STATE OF NORTH CAROLINA
DEPARTMENT OF TRANSPORTATION

Subject: Application for Modification to Section 404 and Section 401 permits and Neuse Buffer Certificate for the Northern Wake Expressway (I-540) from US 1 to US 64 in Wake County, Division 5. State Project No. 8.2401701, Federal Aid Project No. F-123-1(1), TIP No. R-2000 F&G; \$475.00 Debit Work Order 8.2401701, WBS Element No. 34365.1.1. NCDENR-DWQ Water Quality Certification Project No. 030114 and USACE Action ID 199920387.

The purpose of this submittal is to request a modification to the Section 404 permit and Section 401 Water Quality Certification and Neuse Buffer Certificate, specifically for Sections F&G. The modification for the permit is for several changes to jurisdictional and buffer impacts through construction modifications and to state discrepancies found by NCDOT personnel between the permit drawings and the construction plan sheets.

SHEET 47 OF 70

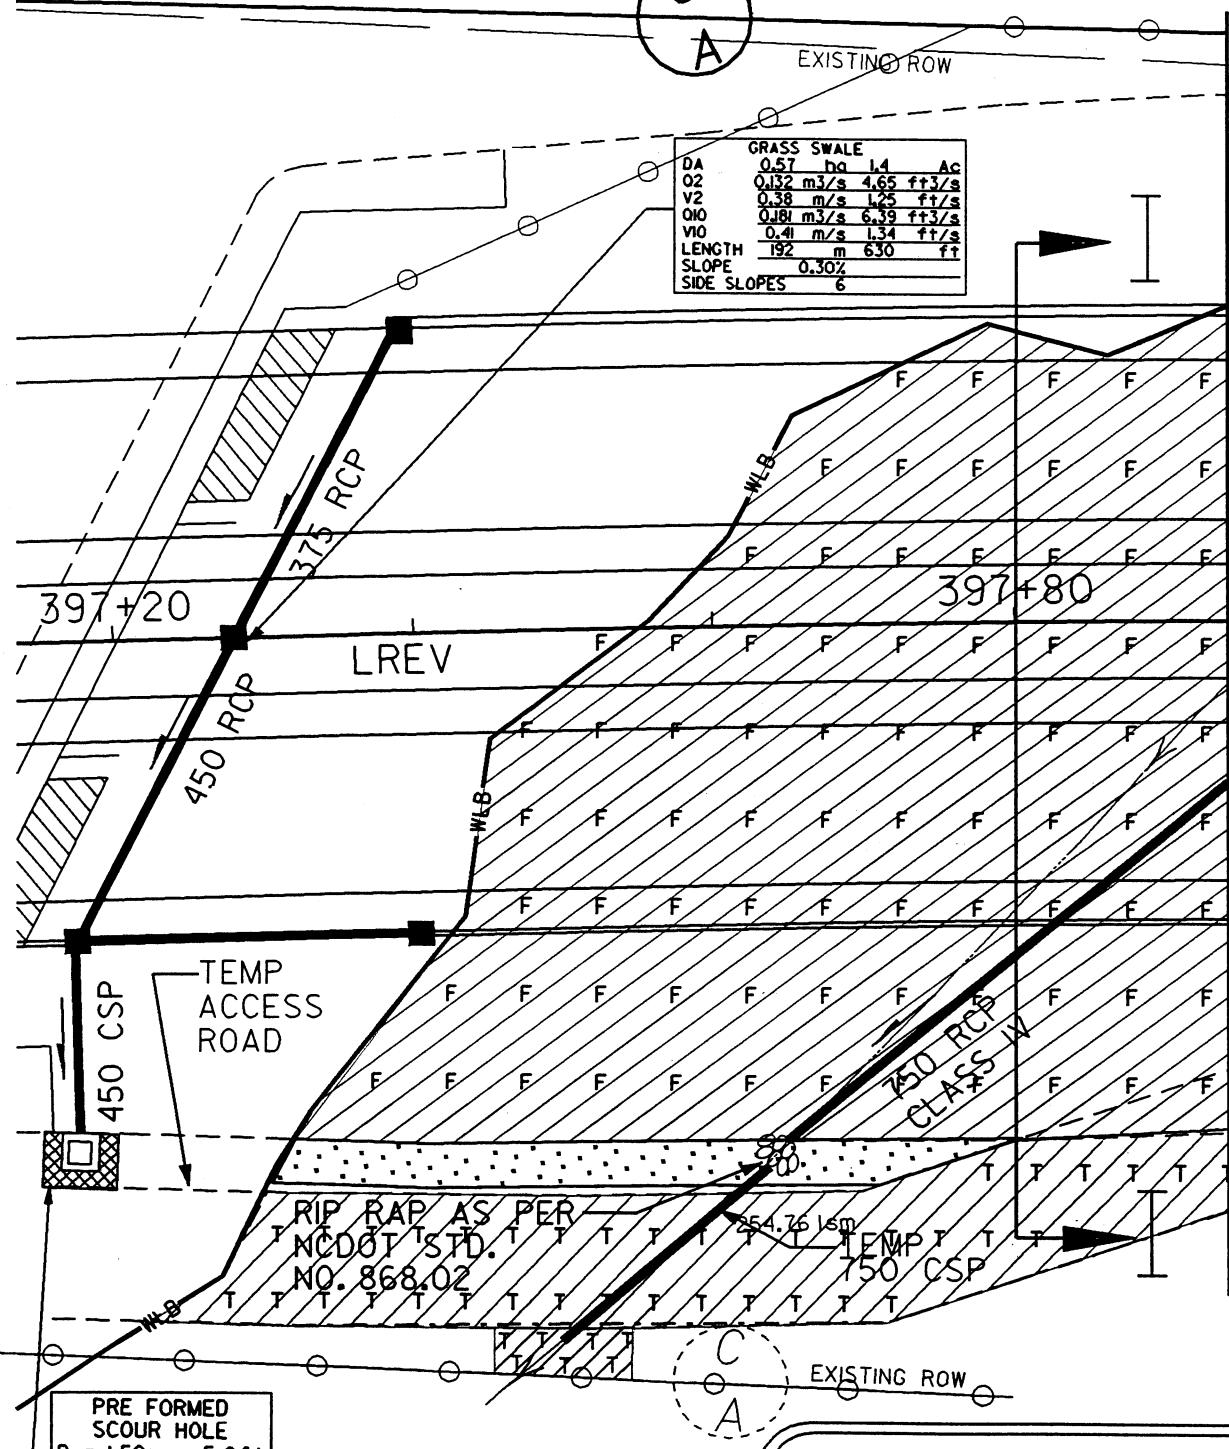
The Permit Drawing 47 will be revised to reflect the proposed finger of the temporary work bridge for the construction of interior bent #3 to be moved from the east side to the west side on interior bent #3. No change in impacts will be required for this specific action.

Plan sheet 17 will be revised to reflect the correct dimensions of the pre-formed scour hole reflected on the approved permit drawing.

SHEET 87 of 90 //

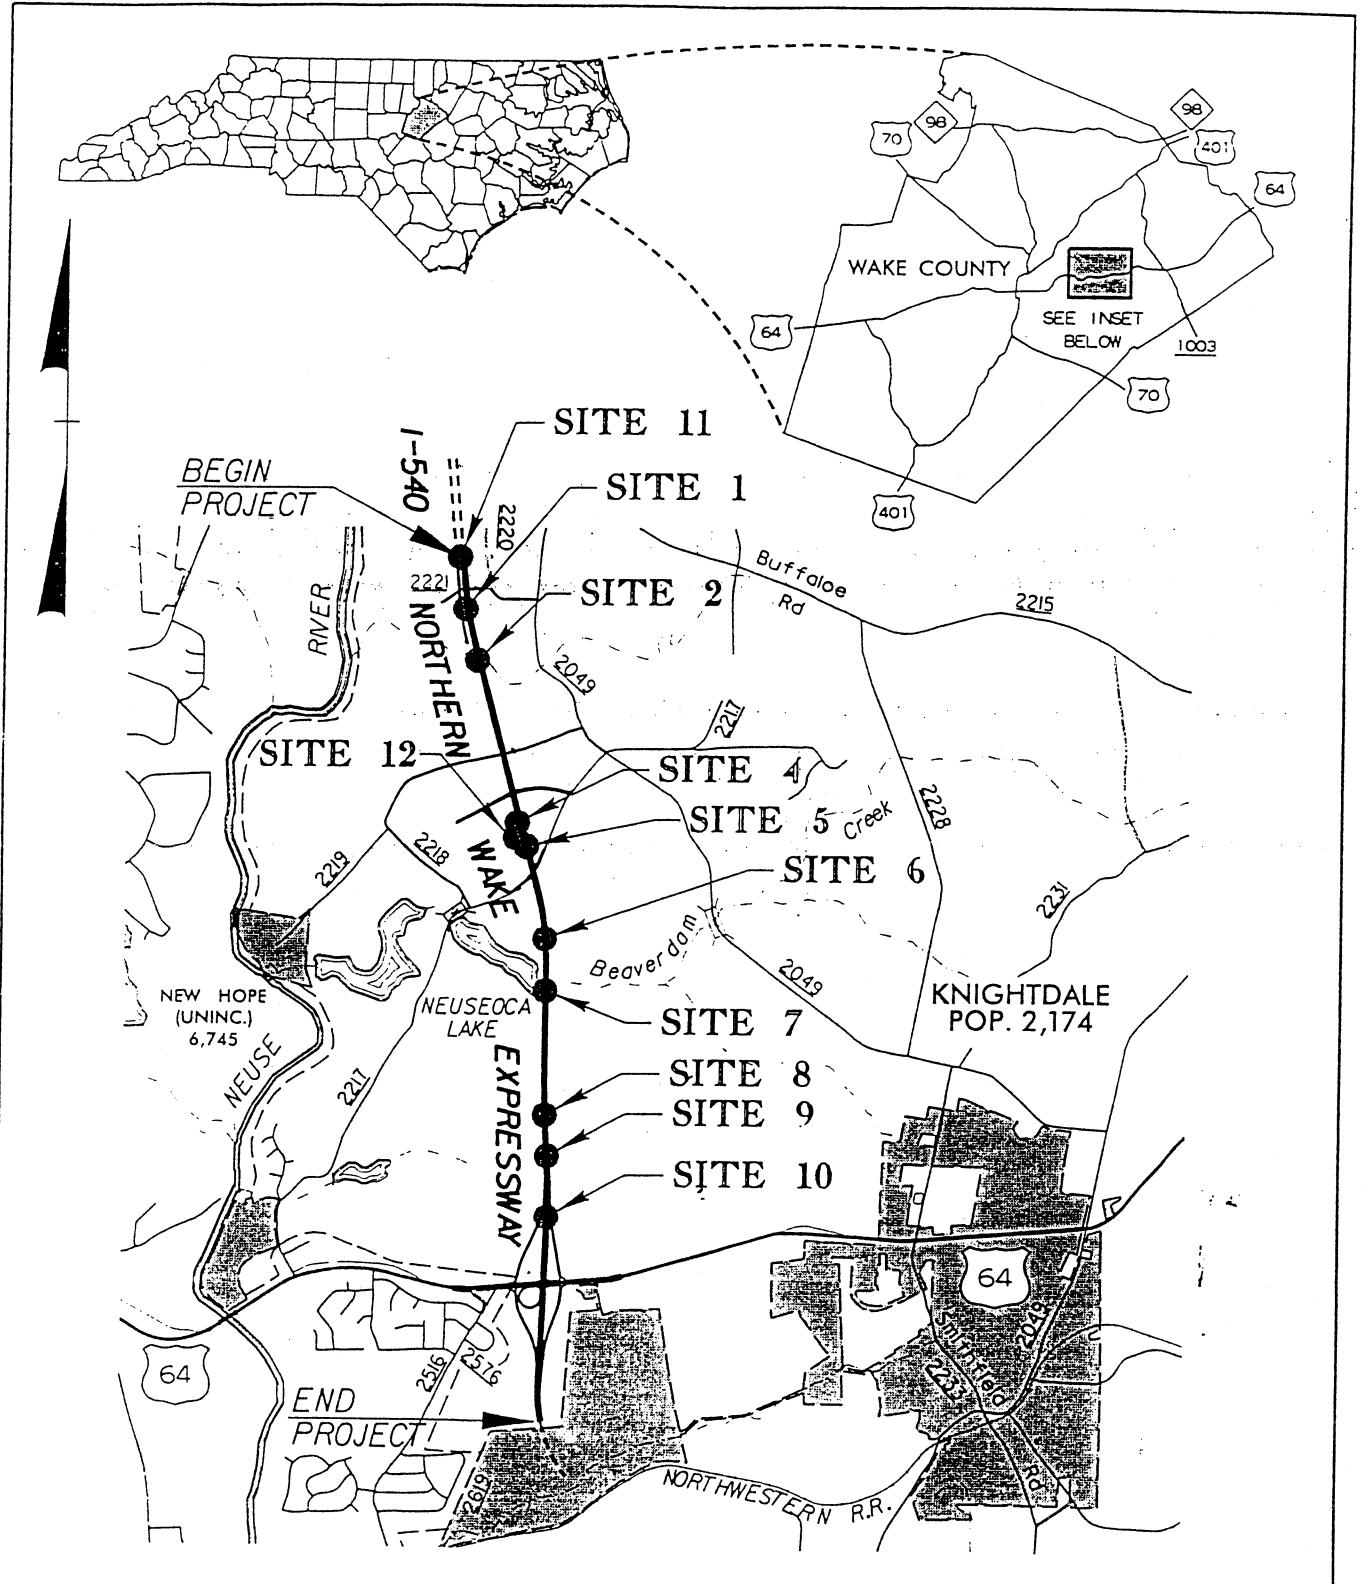
Permit Drawing 87

Permit Drawing revised to reflect change in lateral base ditch from Permit Drawing 63.

PROJECT: 8U401712 (R-2000G)
I-540 NORTHERN WAKE EXPRESSWAY
SHEET 14 OF 50 10//29//02
REVISED 3//4//04
REVISED 9//21//04

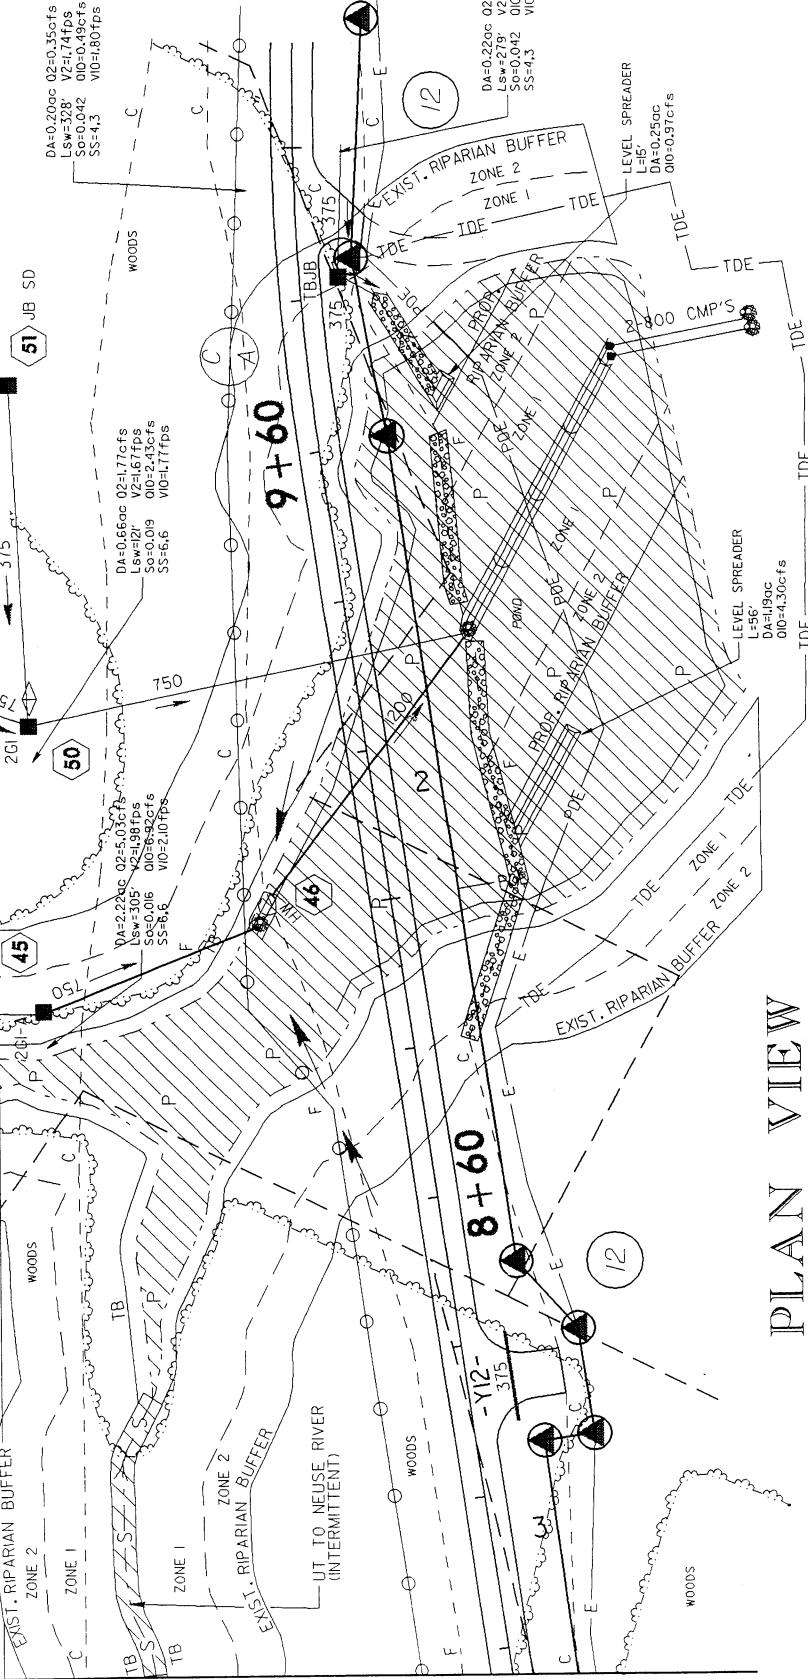
Permit Drawing 14/Plan Sheet 8/Site 12

Permit Drawing 14 was revised to fix the discrepancy of the depiction of the level spreader and the toe protection (near Station 9+70 Rt Y 12) and now matches the construction Plan Sheet 8 dated 3/15/04. There are no changes to jurisdictional or buffer impacts.

This permit drawing was also revised to reflect a change in the hydraulic design at Structures 45 and 46. These structures were moved slightly to conform to existing topography. There are no change in pipe sizes or jurisdictional impacts.
